12/09/20	Deleted Reconstruction Callout R6. Added Reconstruction Callout R5.
DATE	REVISION
STATE OF HAWAII DEPARTMENT OF TRANSPORTATION HIGHWAYS DIVISION	
ROADWAY PLAN	
Vineyard Blvd & Queen Emma St	
ADDITIVE ALTERNATE #1	
Traffic Signal Modernization, Oahu, Phase 1	
Federal-Aid Project No. STP-0300(163)R	
Scale: 1"=10'	Date: Oct. 2020
SHEET No. R-19 OF 81 SHEETS

Traffic Signal Modernization, Oahu, Phase 1

Federal-Aid Project No. STP-0300(163)R

EXISTING CONDITIONS

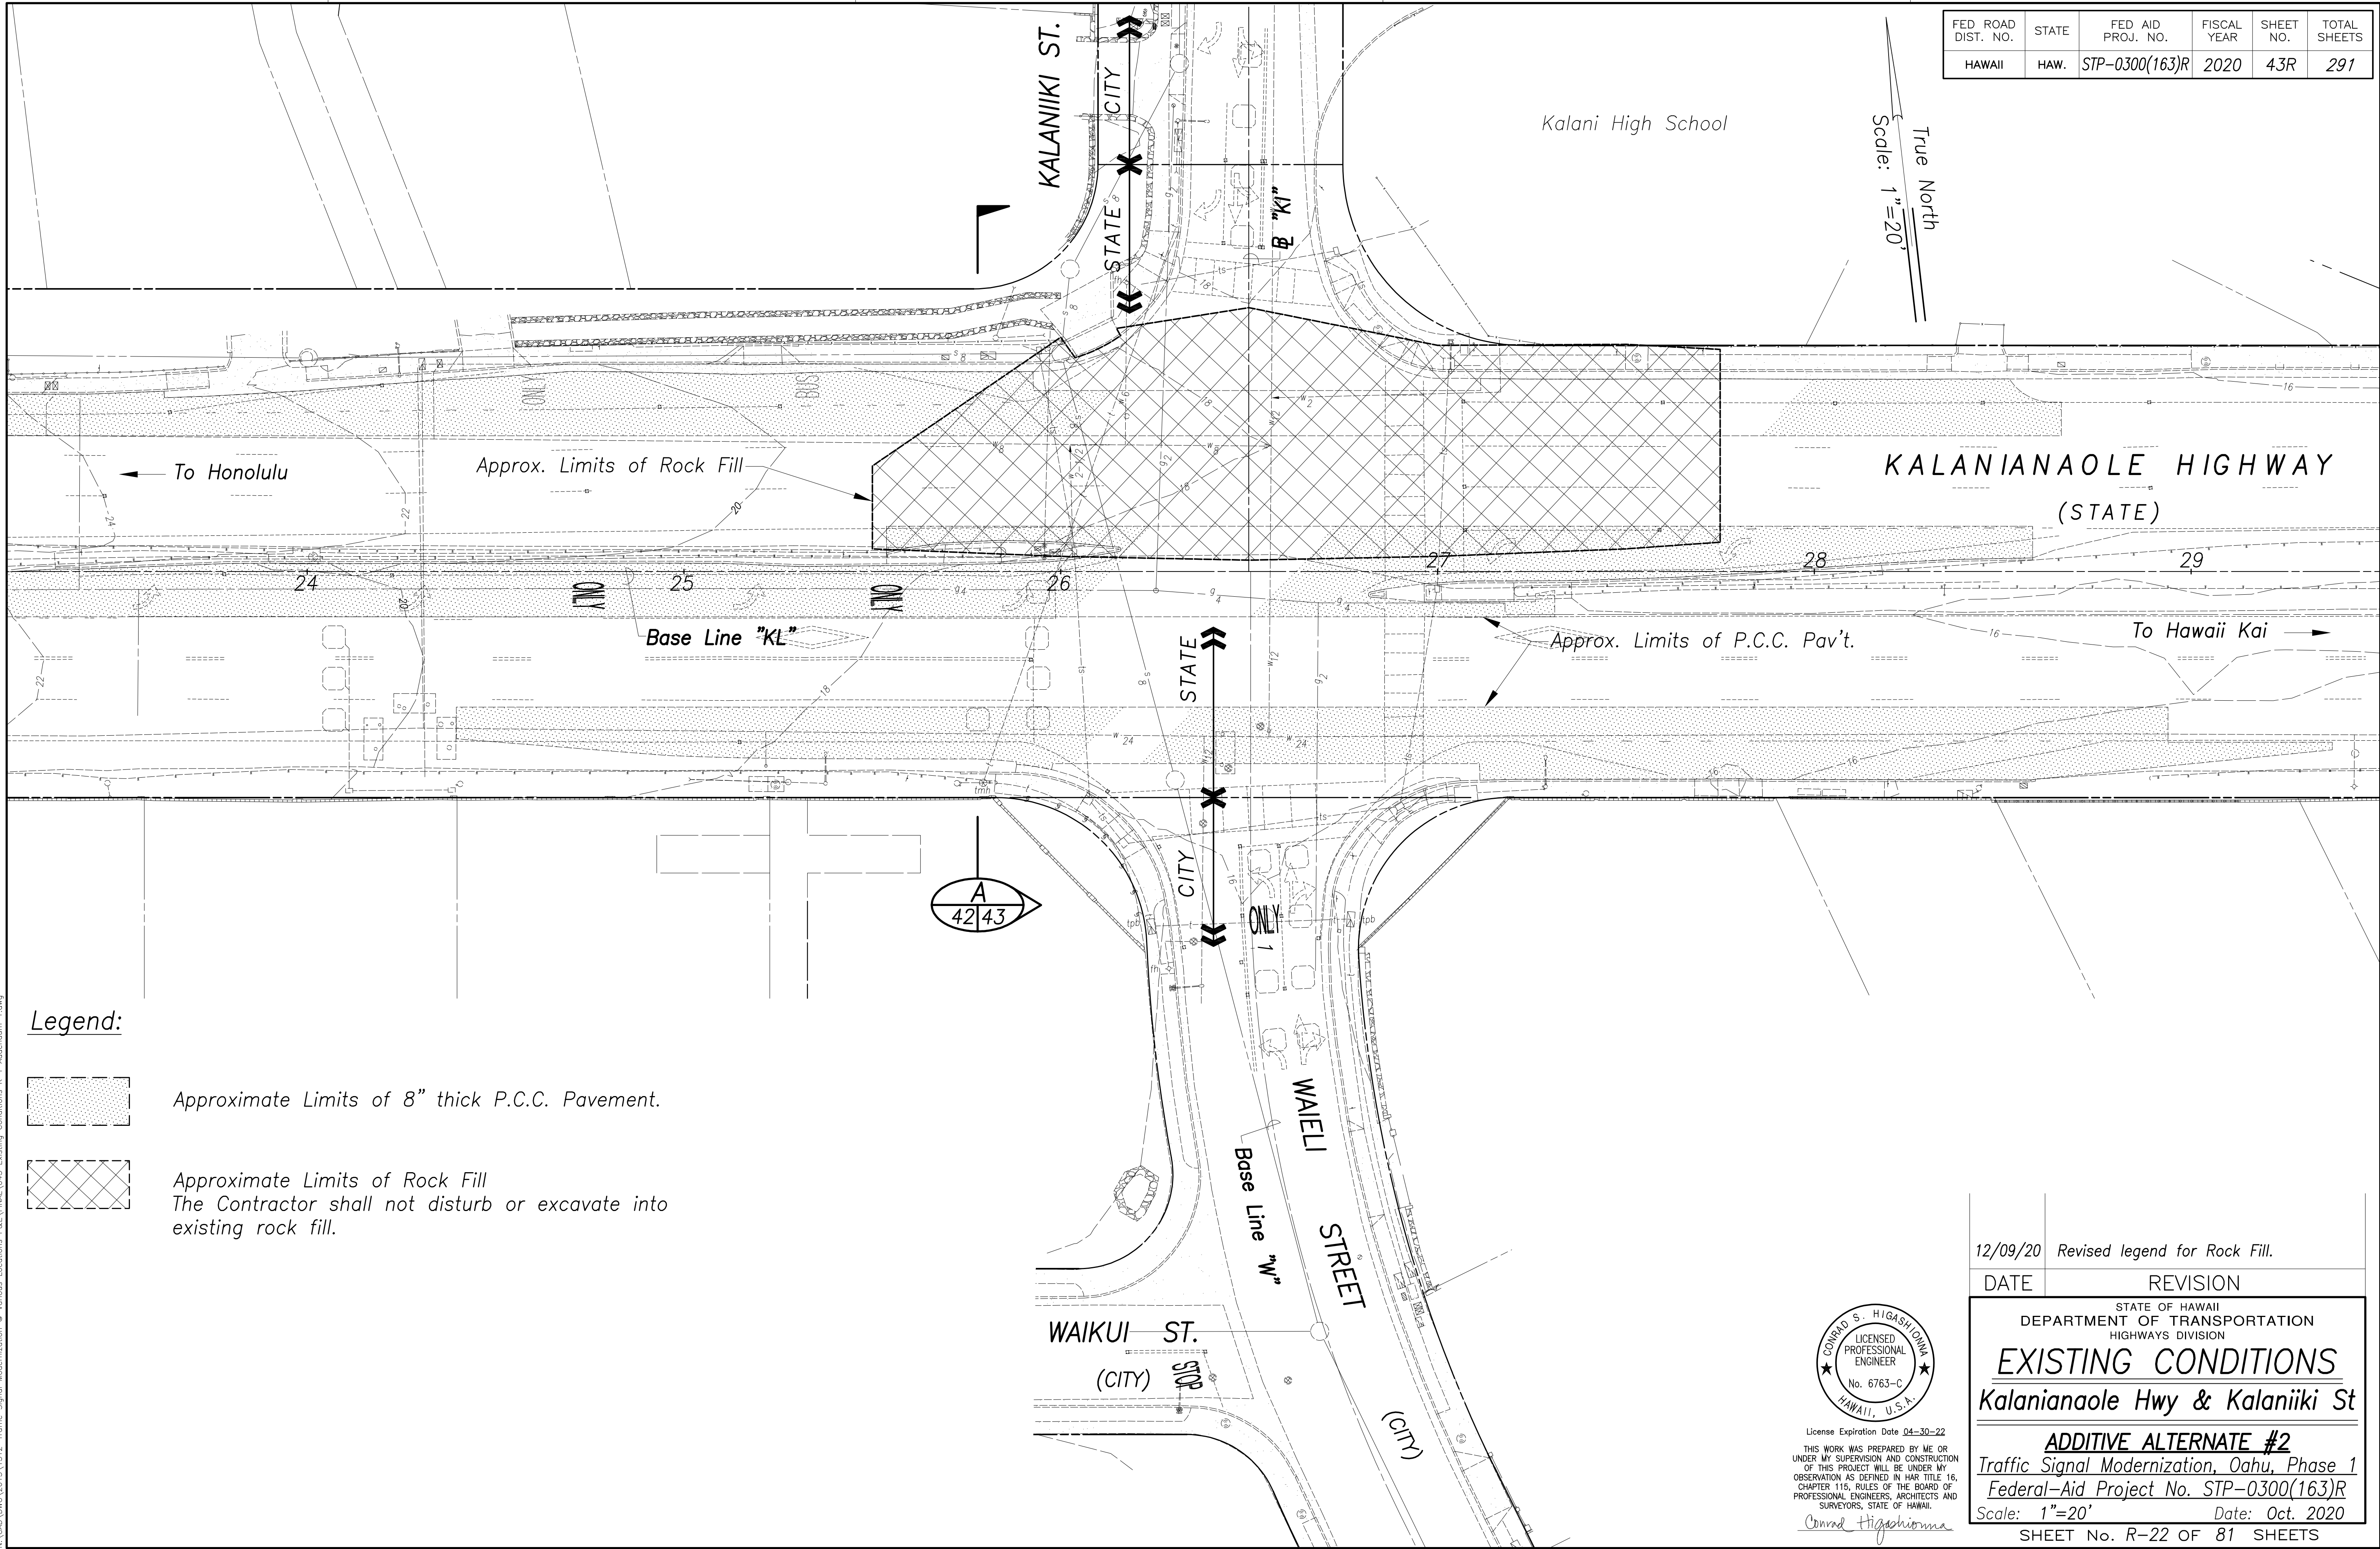
12/09/20 Revised legend for Rock Fill.

Approximate Limits of Rock Fill
The Contractor shall not disturb or excavate into existing rock fill.

SECTION A
Scale: 1"=5'

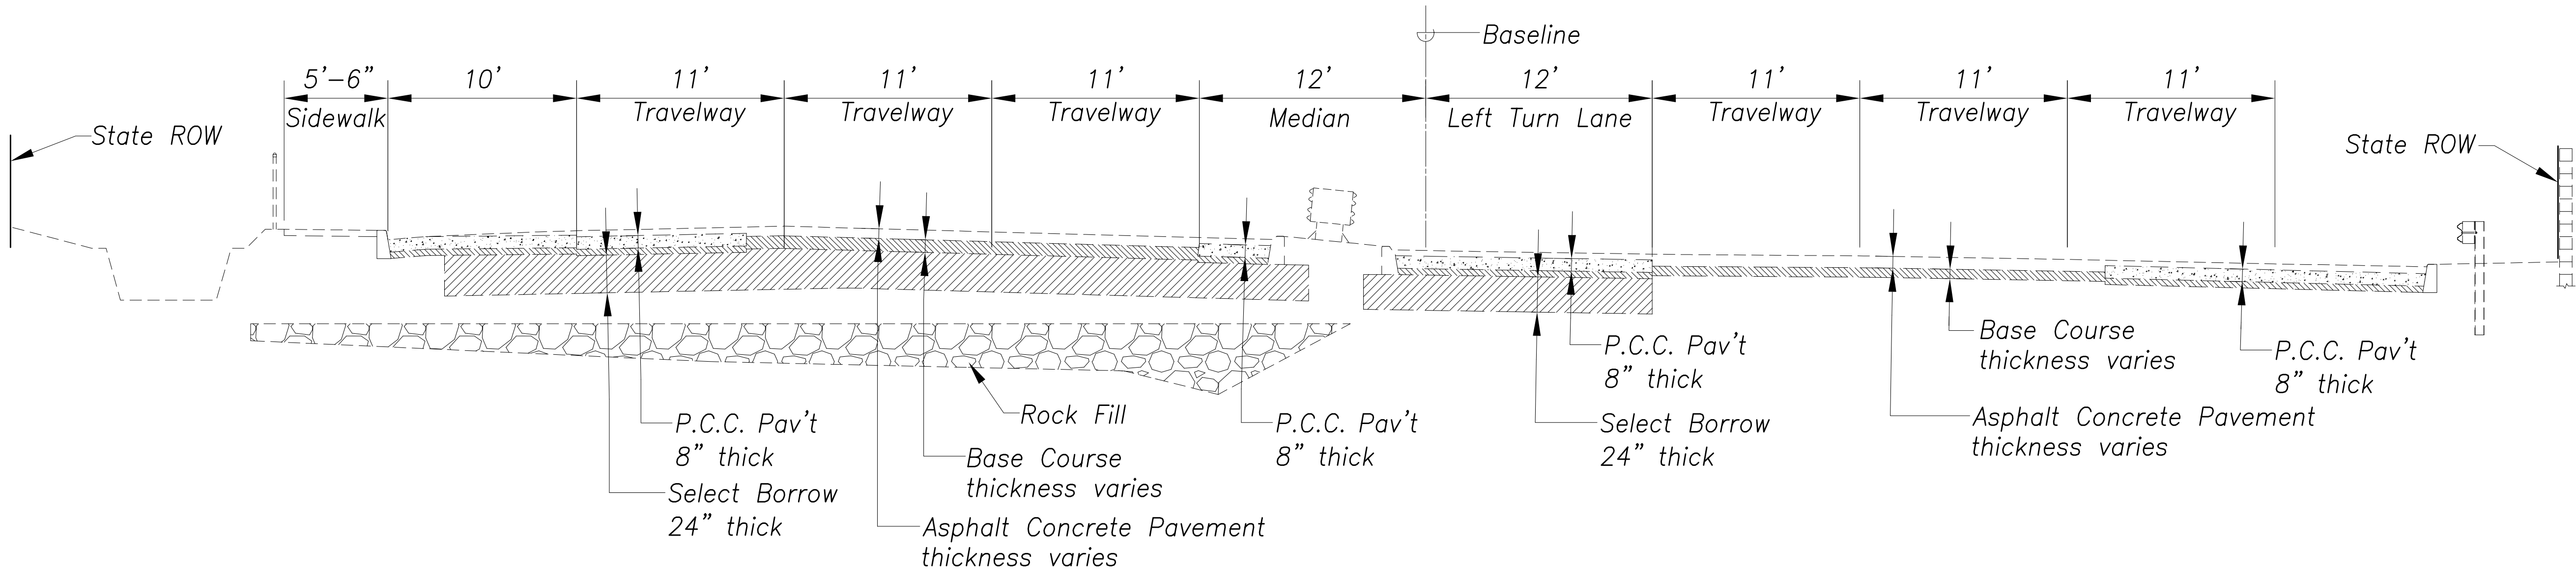
12/09/20	Added note on rock fill.
DATE	REVISION
STATE OF HAWAII DEPARTMENT OF TRANSPORTATION HIGHWAYS DIVISION EXISTING CONDITIONS Kalaniana'ole Hwy & Kalaniiki St ADDITIVE ALTERNATE #2 Traffic Signal Modernization, Oahu, Phase 1 Federal-Aid Project No. STP-0300(163)R Scale: 1"=5' Date: Oct. 2020 SHEET No. R-23 OF 81 SHEETS

The Contractor shall not disturb or excavate into existing rock fill.

STATE OF HAWAII
DEPARTMENT OF TRANSPORTATION
HIGHWAYS DIVISION
ROADWAY PLAN
Kalanianaʻole Hwy & Kalaniiki St
ADDITIVE ALTERNATE #2
Traffic Signal Modernization, Oahu, Phase 1
Federal-Aid Project No. STP-0300(163)R
Scale: 1"=10' Date: Oct. 2020
SHEET No. R-24 OF 81 SHEETS

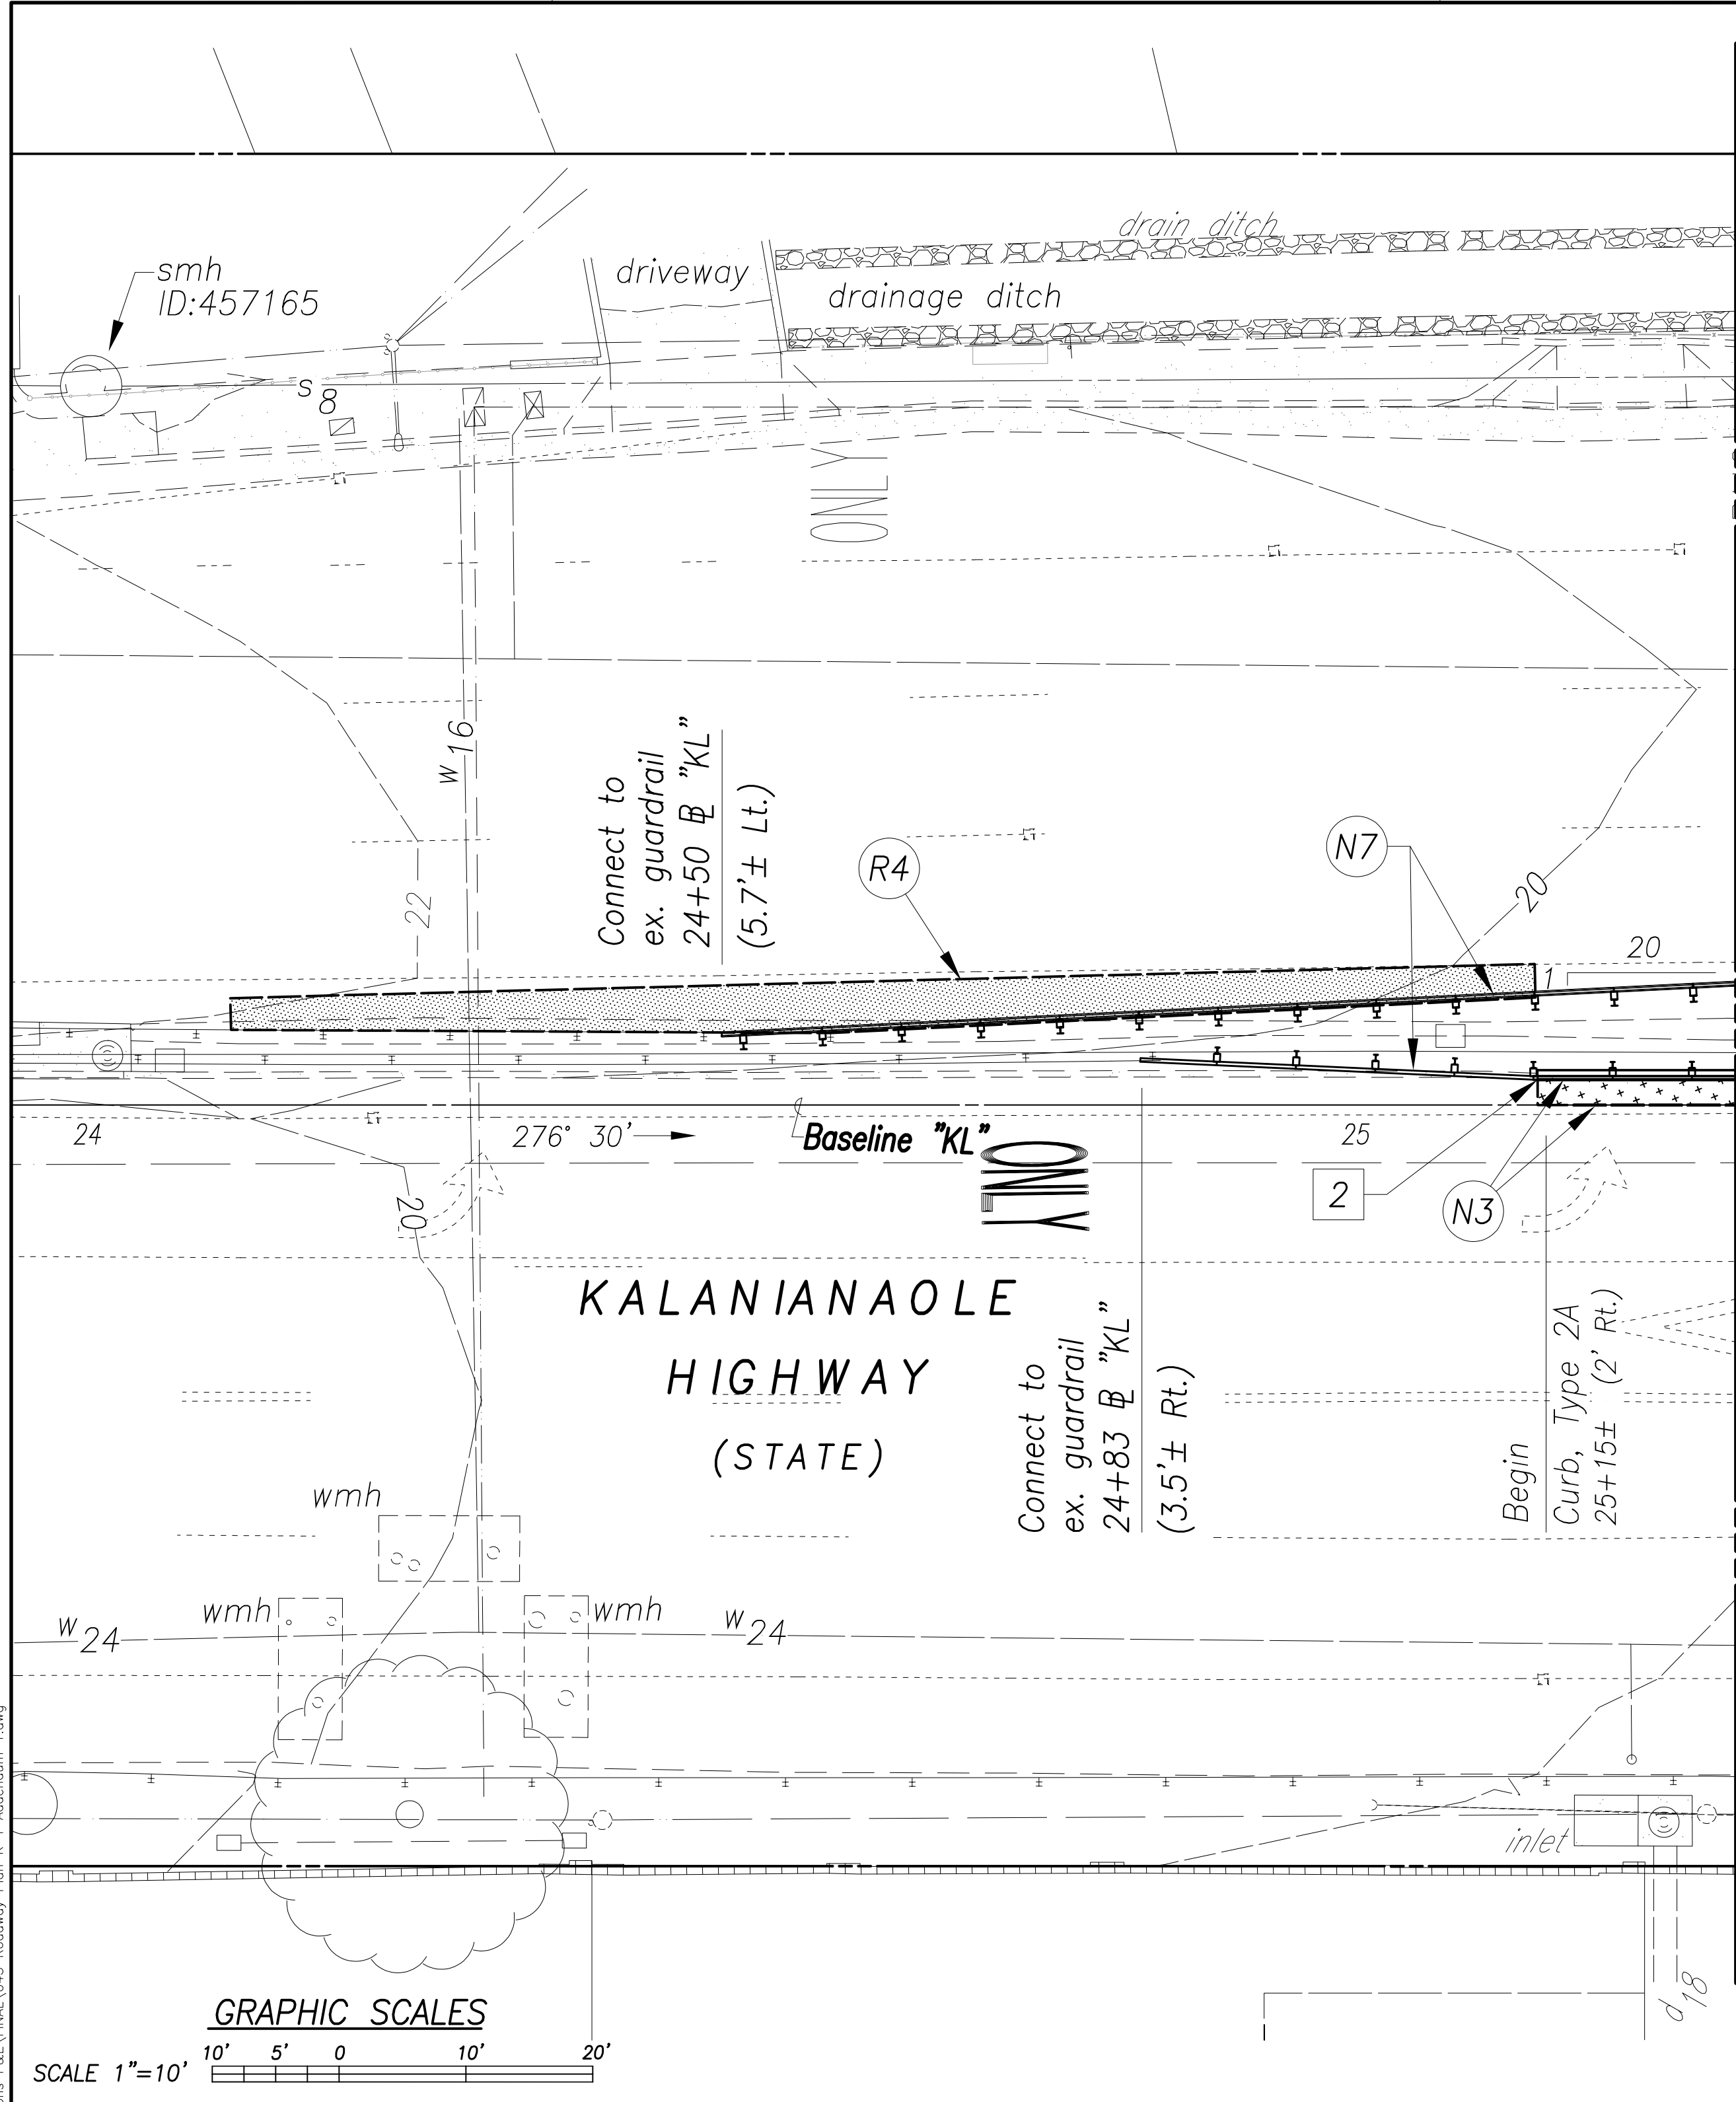
12/09/20 Revised New Construction Callout N8.

- N8 Terminal Impact Attenuator – HDOT Approved MASH Compliant, TL-3; and Transition Section. The Transition Section shall be incidental to the Terminal Impact Attenuator and will not be paid for separately.
